Re: Subdivision Review Application for Final United Village Development Plat by  
Snelling-Midway Redevelopment

## **LOUCKS COMMENTS TO THE PRELIMINARY PLAT CONDITIONS TO BE INCORPORATED INTO THE FINAL PLAT (Red Text)**

Approving the Preliminary Plat for United Village Development.

**COMMENT #3**

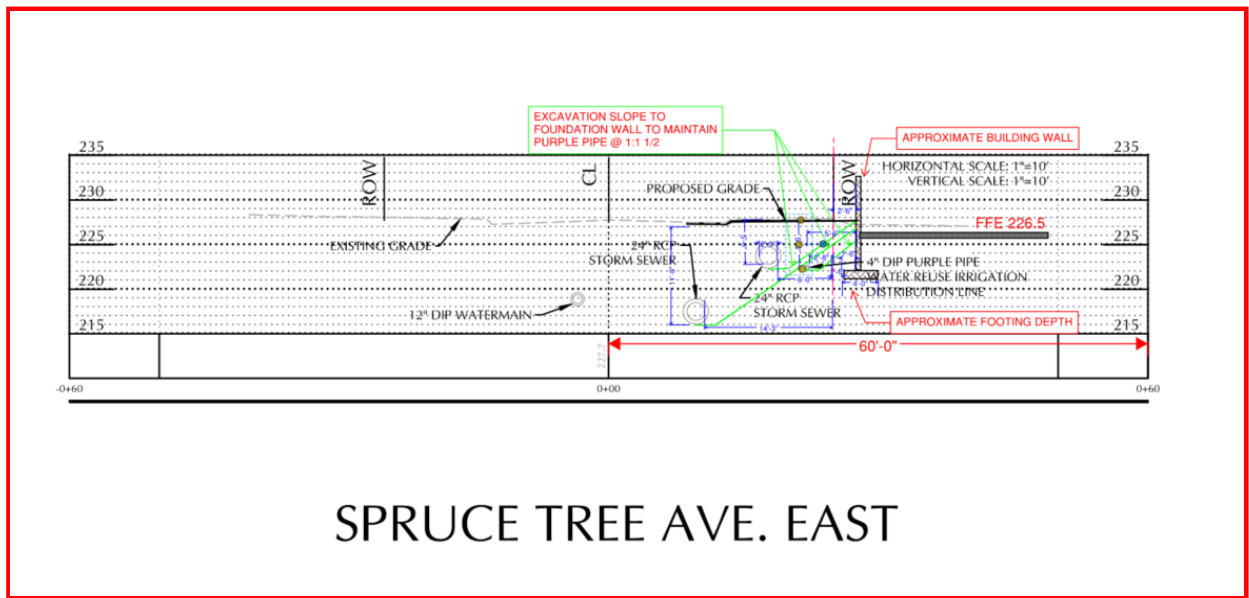
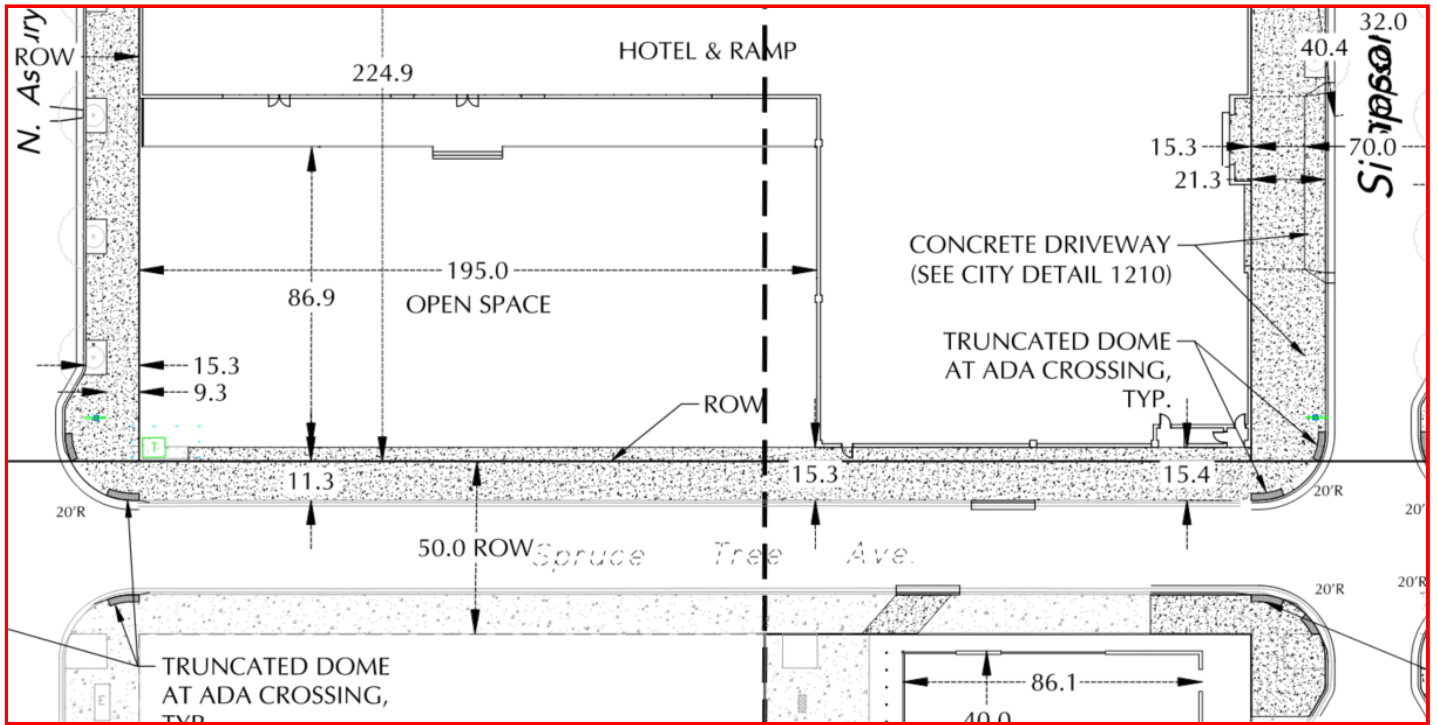
- The developer must incorporate the results and recommendations of the recommendations of the Snelling-Midway Superblock Sanitary Sewer Analysis study, a sanitary sewer capacity analysis being completed for the City by consultant SEH, into the currently proposed development phase as well as all future phases and future private developments to be built on the site. **This was included in Loucks 60% Construction Plan Submittal. See Attached.**

# Midway Superblock Sanitary Sewer Calcs

## SAC Units by use per MCES Appendix A: SAC Criteria
